Staff Report & Recommendation

Historic Preservation Board

SUBJECT: HPB19-0365, **1225 & 1235 Lenox Avenue.**

An application has been filed requesting a Certificate of Appropriateness for the total demolition of the existing single family home located at 1235 Lenox Avenue and the construction of a detached addition, including variances from the required side and sum of the side setbacks.

1235 Lenox Avenue, 1989 Photograph, Historic Properties Database Card

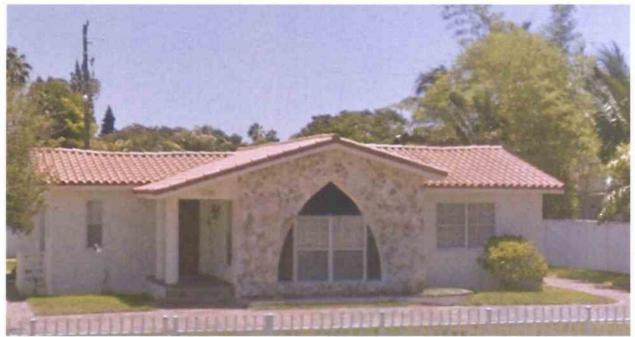
The existing 1-story single family home located at 1235 Lenox Avenue was constructed in 1936 and designed by architect Albert Anis in the Mediterranean Revival/Art Deco Transitional style of architecture. A garage was built at the rear of the site concurrently with the home. In 1990, the house was renovated including the replacement of the entire roof structure as well as a rear addition. Although not evident in the available permit records, staff believes that the alterations to the front façade were completed during this renovation. Modifications to the front façade appear to include the introduction of rough-hewn stone cladding and the removal of the chimney structure. A number of original architectural elements remain including the pointed arch window opening, ornamented surround at the front door and a decorative bracket feature at the front porch. A photograph from 1989 is provided which mostly likely depicts the 1936 Albert Anis façade design.
